# UNITED STATES PATENT AND TRADEMARK OFFICE

APPLICATION NO.	FILING DATE	FIRST NAMED INVENTOR	ATTORNEY DOCKET NO.	CONFIRMATION NO.
10/652,359	08/29/2003	David W. Grunow	16356.821 (DC-05237)	1316
27683	7590	02/24/2005	EXAMINER	
HAYNES AND BOONE, LLP 901 MAIN STREET, SUITE 3100 DALLAS, TX 75202			PAPE, ZACHARY	
			ART UNIT	PAPER NUMBER
			2835

**Office Action Summary**

## DETAILED ACTION

Fig 1

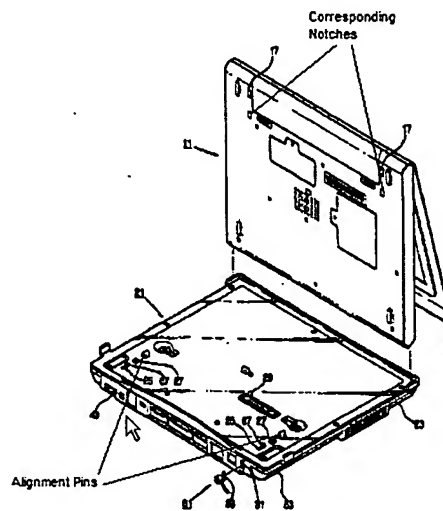
4. With respect to claim 10, Won et al. further teaches the use of a docking system operable to detachably dock a portable device, the system comprising: a pair each of moveable rear latches (67), wherein the pair of moveable rear latches (67) are operable to latch on to corresponding matching slots (17) of the portable device in response to an application of a substantially vertical force on the portable device for docking, and a pair of alignment pins, wherein the pair of alignment pins are operable to mate with corresponding notches on the portable device when the portable device is docked.

(See present office action Fig 1)

20. With respect to claim 2, Won et al. teaches the use of alignment pins included in the docking device with corresponding notches on the portable device. (See present office action Fig 1).

21. With respect to claim 3, the application of the vertical force (to the computer 11 of Won et al.) causes the pair of alignment pins to mate with the corresponding notches.

22. With respect to claim 4, Won et al. further teaches a substantially planar bottom section (surrounding 29), capable of being placed on a stable surface, wherein the pair of moveable rear latches (17) and moveable front latches are affixed to the bottom section, wherein the pair of moveable rear latches and moveable front latches are aligned substantially perpendicular to the bottom section (As illustrated in Fig 1), a
